## **Proposal for a draft Supplement to the 03 series of amendments to UN Regulation No. 79**

**Submitted by the experts from the International Organization of  
Motor Vehicle Manufacturers and European Association of  
Automotive Suppliers\*\***

The text reproduced below was prepared by the experts from the International Organization of Motor Vehicle Manufacturers (OICA) and European Association of Automotive Suppliers (CLEPA). It contains a proposal for amendments to the requirements for Automatically Commanded Steering Functions (ACSF) of Category C, which has been adopted by WP.29 in March 2018. This text proposes specific provisions for the use of a lane change function with a so-called two-step Human Machine Interface (HMI). The original proposal has been amended, taking into account the comments received from contracting parties at the 1<sup>st</sup> session of GRVA (September 2018). The modifications to the existing text of the Regulation (in ECE/TRANS/WP29/2018/35) are marked in bold for new, and strikethrough for deleted characters.

### 5.6.4.6.4.1 Automatic initiation of the lane change manoeuvre

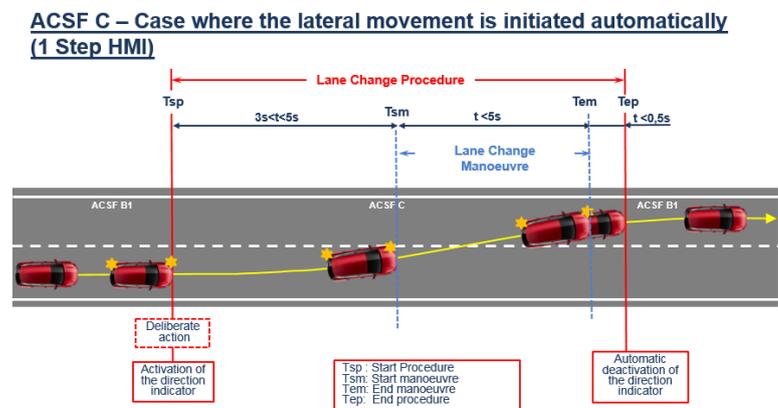
"5.6.4.6.4. The lateral movement of the vehicle towards the intended lane shall not start earlier than  $\pm 1.0$  second after the start of the lane change procedure. Additionally, the lateral movement to approach the lane marking and the lateral movement necessary to complete the lane change manoeuvre shall be completed as one continuous movement.

~~The lane change manoeuvre shall not be initiated before a period of 3.0 seconds and not later than 5.0 seconds after the deliberate action of the driver described in paragraph 5.6.4.6.2. above.~~

**The lane change manoeuvre shall be initiated either automatically or by a second deliberate action of the driver.**

**In case of an automatic initiation the lane change manoeuvre shall commence between 3.0 seconds and 5.0 seconds after the manual activation of the procedure as described in paragraph 5.6.4.6.2. and shown in the Figure below.**

**ACSF C – Case where the lateral movement is initiated by a second deliberate action by the driver (2 Step HMI)**

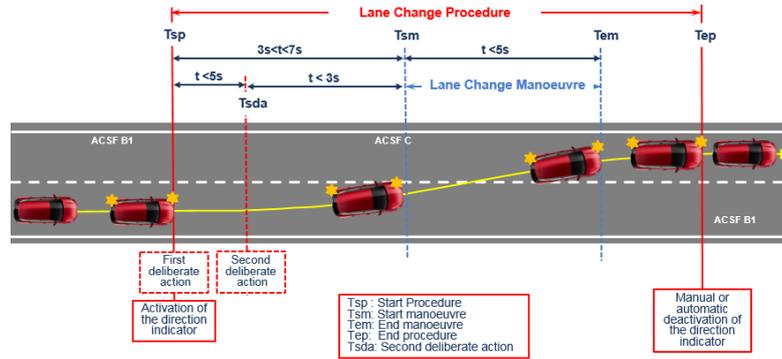
**In case of an initiation by a second deliberate action the lane change manoeuvre shall commence between 3.0 and 7.0 seconds after the manual activation of the procedure as described in paragraph 5.6.4.6.2.**

**Additionally, the lane change manoeuvre shall commence at the latest 3.0 seconds after the second deliberate action as shown in the Figure below.**

**The control to operate the second deliberate action shall be located in the steering control area."**
